TO: Jacob Dalton
PROJECT #: 22-1659-A
PAGE: 1 of 3
DATE: November 19, 2024
LOCATION: Dalton Residence Yellow Brick Road, Pittsboro
PLAN REF: Dalton Residence by Diane Rives Design
Project# 22-1659

THE FOLLOWING CHANGE(S) OR PROPOSED CHANGE(S) LISTED BELOW ARE DEVIATIONS OR CLARIFICATIONS FOR THE ABOVE REFERENCED PLANS:

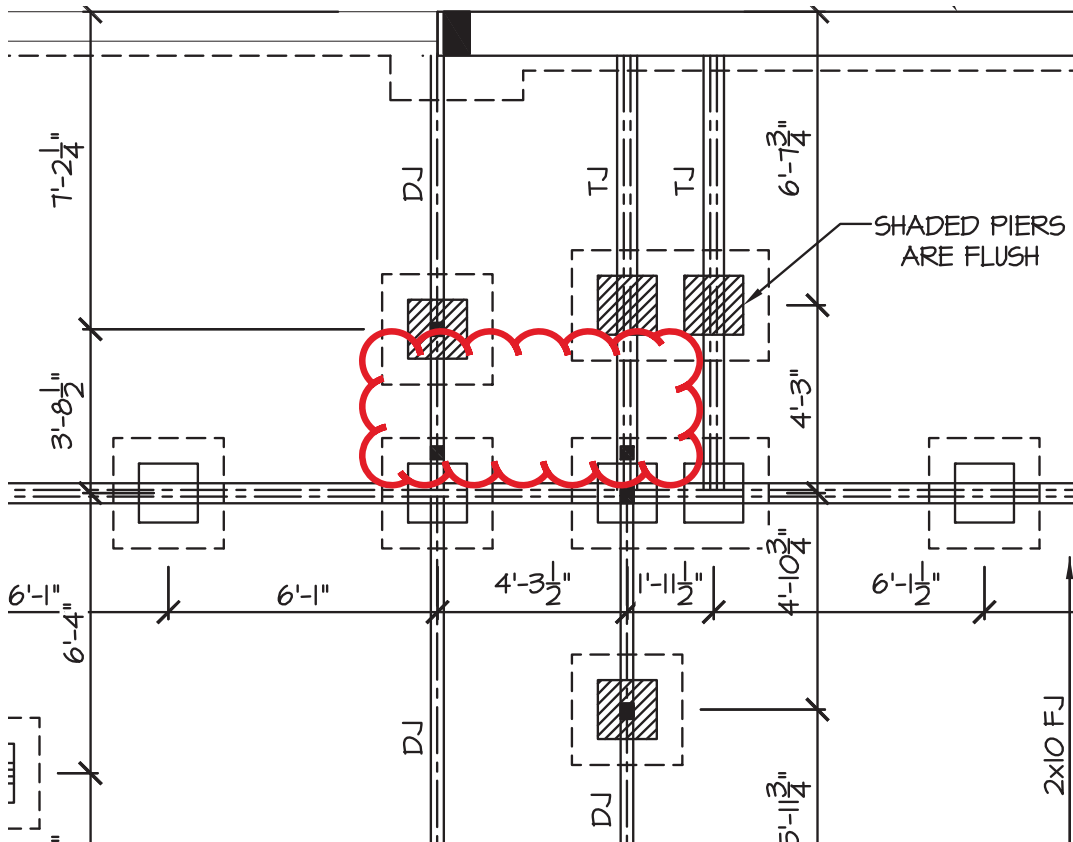
D. LVL Shift and LVL Omission: Per information provided by the builder the (3) 1.75 x 14" LVL in the Family Room was shifted to be about 8' from the slider door. The (3) 1.75 x 14" LVL was run long over the stairs. This extension made the (2) 1.75 x 9.25" LVL originally designed to go over the stairs obsolete. The shifted (3) 1.75 x 14" LVL that was shifted is supported by (4) 2 x 4 stud columns that hit over the triple joist and double joist in the crawl space as indicated in the image below.

Response: Please note that the LVL shift, extension and the omission of the LVL over the stairs as described above is acceptable provided that the double joist and triple joist in the crawl space have a (1) 1.75 x 9.25 LVL attached with (3) 10d nails every 6" to each side of the double and triple joists.

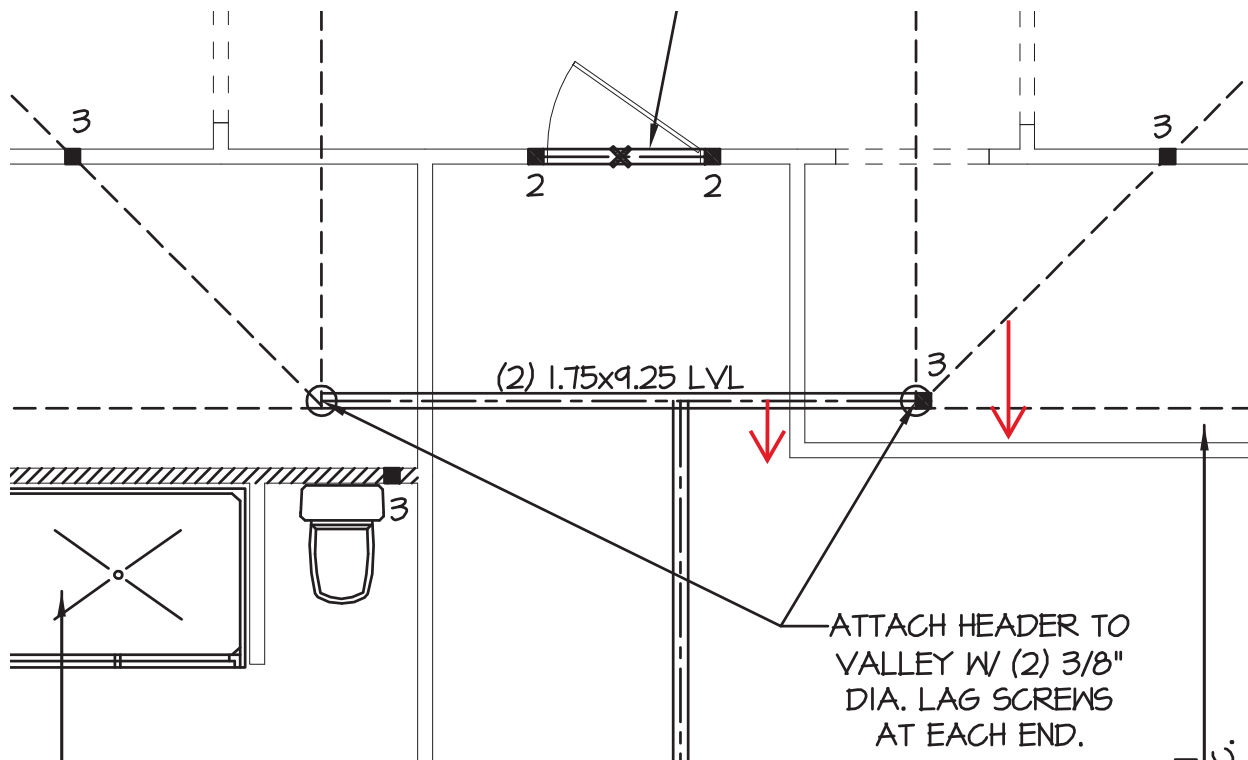
E. LVL Header and Valley shift: The original plans specify the (2) 1.75 x 9.25 to attach to the valleys with (2) 3/8" diameter lag screws and be supported with a (3) 2 x 4 stud column. Per information gathered on a site observation on 11/14/24 the (2) 1.75 x 9.25" LVL was shifted forward to match the shift from the (2) 1.75 x 9.25" LVL valley above. The shift now has the valley supported by (3) 2 x 4 stud column in the wall on the right and a (3) 2 x 4 stud column in the bathroom wall on the left. The (3) 2 x 4 stud columns on each side are supported by the (2) 1.75 x 16" LVLs below. Please refer to the image below to visualize the shift from the (2) 1.75 x 9.25" LVL header and valley.

Response: Please note the LVL header and LVL Valley shift described above is acceptable.
